NEW DESIGN OF CONTROL PANEL

Old control panel

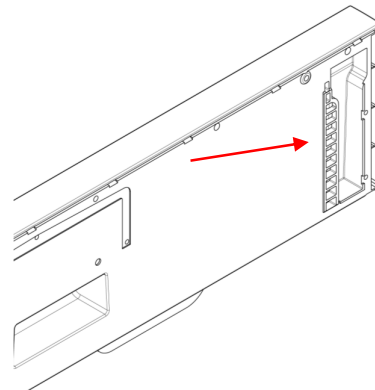
Control panels 1561441021 and 140003091026 will not be available. It can be replaced by part 140003091034, but new panel is not dedicated for IKEA "RESONLIG" set. Due to this it is necessary to remove mentioned set and replace some additional components.

Depending on the method of installation following parts should be used:

2. Dishwasher was installed with IKEA "RESONLIG" set:

Description	Spare part code	Quantity
Control panel	140003091034	1
Outer door	1560285866	1
Inner door	140025959028	1
Hinge kit	4055350963	1
Mounting kit	1561714005	1
Template	140021487032	1
Hinge rod	1172954040	1
Distance piece	140025501010	1
Manual	1561703024	1
Door gasket	1527401002	1
